VIRGINIA ELECTRIC AND POWER COMPANY
SURRY POWER STATION UNITS 1 AND 2
LICENSE AMENDMENT REQUEST - APPLICATION OF RISK-INFORMED
APPROACH FOR TORNADO CLASSIFICATION OF THE FUEL HANDLING
TROLLEY SUPPORT STRUCTURE
SUPPLEMENTAL INFORMATION

RESPONSE TO NRC REQUEST FOR SUPPLEMENTAL INFORMATION

APPLICATION OF RISK-INFORMED APPROACH FOR TORNADO
CLASSIFICATION OF THE FUEL HANDLING TROLLEY SUPPORT STRUCTURE

Virginia Electric and Power Company
(Dominion Energy Virginia)
Surry Power Station Units 1 and 2

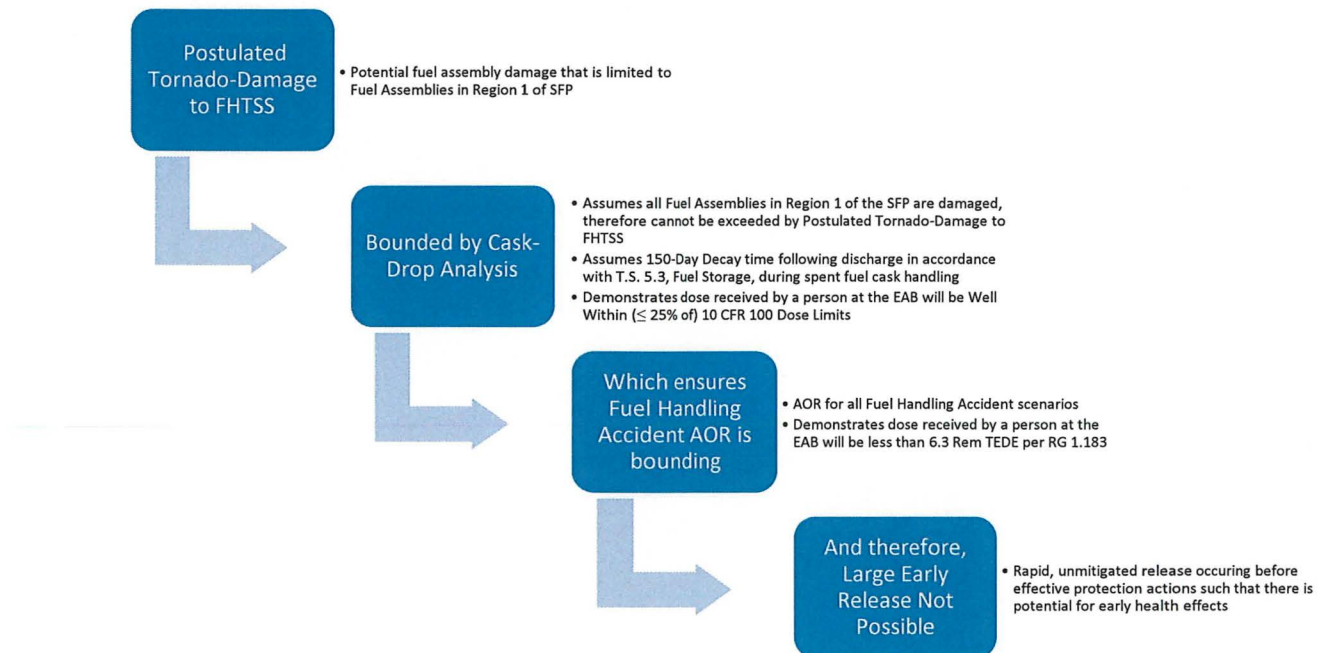
- 1. A justification for the statement that a potential release resulting from spent fuel damage is expected to be bounded by the fuel accidents analyzed under the design basis, including the cask-drop and fuel handling accidents. For this item, the licensee needs to include: (1) a description of the accident scenarios and radiological conditions considered when evaluating a potential radioactive release resulting from*

tornado wind damage to the FHTSS, and (2) a description of the methodology and results of the analysis demonstrating that a potential radioactive release resulting from tornado wind damage to the FHTSS is bounded by the failure of all 324 fuel assemblies stored in the first three rows of storage racks adjacent to the cask loading area.

Civil/structural assessment concluded spent fuel damage resulting from falling structural members of the FHTSS was limited to Region 1. Because the spent fuel cask drop accident radiological dose analysis assumes all 324 assemblies in Region 1 are damaged, the extent of spent fuel damage and radiological dose consequences resulting from a spent fuel cask drop accident were concluded to bound those associated with FHTSS structural failure. The dose consequences of the cask drop accident analysis are, in turn, bounded by the FHA analysis of record (AOR). The FHA analysis demonstrates the dose consequences at the exclusion area boundary (EAB) meet the acceptance criterion of 6.3 Rem TEDE, per Regulatory Guide 1.183. As described further in the response to NRC Request No. 2, the radiological consequences of an FHA are much less than those associated with a Large Early Release, defined by the PRA standard¹ as “the rapid, unmitigated release of air-borne fission products from the containment to the environment occurring before the effective implementation of off-site emergency response and protective actions such that there is a potential for early health effects.” Additional background on supporting evaluations is presented below.

FHTSS structural failure is postulated to result in the structure partially or fully collapsing. In the worst-case, both ends of structural members may detach from the FHTSS and fall into the SFP, thereby impacting stored spent fuel assemblies or the SFP walls or mat. SFP inventory and fuel cooling integrity are maintained in this scenario because falling FHTSS members do not have enough energy to perforate the reinforced concrete SFP structure, and the fuel cooling components are not located where they could be impacted by falling members. Since SFP leakage and/or loss of cooling aren’t credible, the dose consequence evaluation is limited to direct damage caused by falling members that impact spent fuel assemblies. This scenario could release gaseous fission products from the fuel rods into the fuel building; however, fission products contained in the fuel pellets would not be released since decay heat removal is not at risk of being lost.

The yellow highlighted area of Figure 1 shows the area of concern known and referred to as the “High Bay”. The blue highlighted area shows the area SPS defines as “Region 1” of the SFP. Based on civil and structural assessment, any postulated failure of the High Bay caused by a tornado would result in limited damage, if any, to spent fuel assemblies, and any damage to spent fuel is assessed to be limited to only Region 1.
